Planning Division  
15151 E. Alameda Parkway, Ste. 2300  
Aurora, Colorado 80012

**Re: Third Submission Review:** Popeye's at Citadel – Site Plan and Conditional Use  
**Application Number:** DA-1422-17  
**Case Numbers:** 2017-6017-09; 2017-6017-10

## Third Submission Review

#### Sheet 3/Site Plan

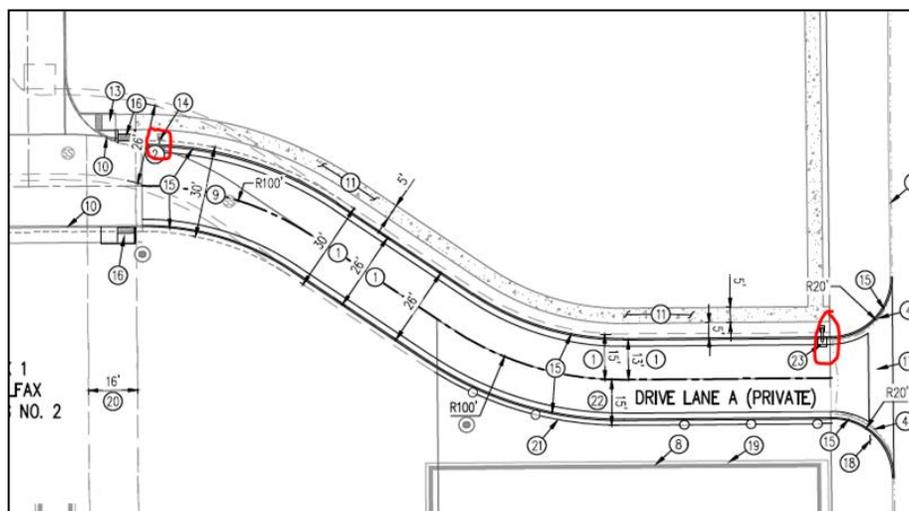
1D. Label both streets as “to be completed by others prior to construction acceptance or building occupancy of the Popeye’s site”.
